Date of Issue:	24 March 2025
To:	Timaru District Council c/- Jen Vella, Legal advisor Anderson Lloyd
Copy to:	Council's section 42A Reporting Officer, Liz White, consultant planner
Project :	Proposed District Plan Noise Chapter – Response to Technical Noise Issues Raised
Prepared By :	Malcolm Hunt, Malcolm Hunt Associates

Proposed District Plan – Response to Technical Noise Issues Raised For Inclusion in Council's section 42A Report

Appendix A – Response to Technical Questions Raised Within Submissions on the Proposed Timaru District Plan Noise Provisions

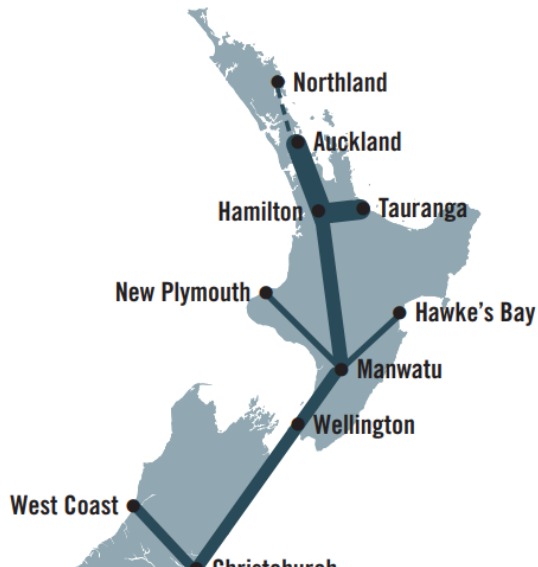
KiwiRail [187.77]	Seeks that the rule is amended to apply within 100m (rather than 40m) of the railway line, because noise and vibration can create adverse health and amenity effects, and an impact on the amenity of residents of a building. The submitter also seeks that PER-1 is amended to apply to an alteration to an existing building, PER-1.2 amended to add “<i>excluding acoustic insulation installed to address rail noise</i>”; and PER-2.b amended to require a 50m rather than 20m setback. Note - the submitter also seeks the inclusion of a new condition which requires compliance with a new standard (NOISE-S7) – this is separately addressed below).	The submitter seeks amendment to provide a specific rule clause for habitable rooms in a new building or altered building within 100m of the rail corridor. NOISE-R9 currently requires acoustic insulation and ventilation for habitable rooms located any site within 40m of the railway line as the area within 40m of the railway line is considered likely to receive whole-day noise exposure levels beyond those normally acceptable for noise sensitive uses. Assessing transportation noise effects within road or rail corridors needs to be assessed on a 24 hour basis, thus it is noise from daily movements which need to be taken into account (rather than average noise levels over periods of one hour which seems to be the preferred approach of the submitter). While extending the application of NOISE-R9 to apply to within 100m may be appropriate for some busy rail routes (with frequent daily train movements) however the South Island Main Trunk railway line is not a busy line with few movements per day. This is confirmed in the following diagram⁵ which shows (using proportionate line thickness) how freight tonnages drop significantly for rail activity south of Christchurch;

This figure shows NZ Rail freight tonnages as published within “<i>Aotearoa New Zealand’s surface freight task – road and rail</i>” by <i>la Ara Aotearoa</i> Transporting New Zealand, November 2021. Given the limited number of daily rail movements (including infrequent passenger trains) there is no indication that rail noise levels received beyond 40m from the railway line would be sufficient to require the acoustic protection provided by NOISE-R9. The submitter also seeks the inclusion of a new condition which requires compliance with a new vibration standard (NOISE-S7) – this is separately addressed below within the response to KiwiRail [187.80].
Te Rūnanga o Ngāi Tahu [185.53]	Considers the potential noise risk could be much lower than indicated in the Background Report and therefore the rules could be excessive. The submitter seeks that the rule is reviewed by engaging an acoustic expert to assess the generated noise, vehicle speeds and times it is generated on the state highway and railway networks and based on that assessment re- assess if the rules are protecting human health at their current setbacks (noting main concern appears to be Māori Purpose Zone). They specifically refer to the MHA Stage 2 Report (p. 26) and the comment in it that the noise insulation against busy roads is acceptable in principle however some aspects need to be confirmed and clarified prior to implementing any specific recommendation within the new proposed plan. The submitter states that the general, 7-year- old national guidance that is not Timaru specific may restrict the ability for iwi to develop their own land.	Given the nature and scale of noise effects on people described in my Stage 1 Noise Report⁶ and the Stage 2 Noise Report⁷ I consider that the protection provided by NOISE-R9 and NOISE-S3 are reasonably necessary in accordance with Council’s duties under the RMA, albeit imposing certain costs and restraints on the development of the district. I consider the controls are reasonably necessary to not only to protect people from adverse effects but also to help ensure the long term sustainability of the road and rail network for the benefit of all who travel to or from Timaru or pass through the district including those industries and commercial undertakings in the Timaru district reliant on freight movements. The provisions outlined in NOISE-R9 and NOISE-S3 are considered consistent with the Council’s obligations to manage the effects of noise under RMA s.31(1)d. I therefore recommend the measures outlined within the notified version of NOISE-R9 and NOISE-S3 therefore be retained, with modifications as recommended elsewhere in this document.
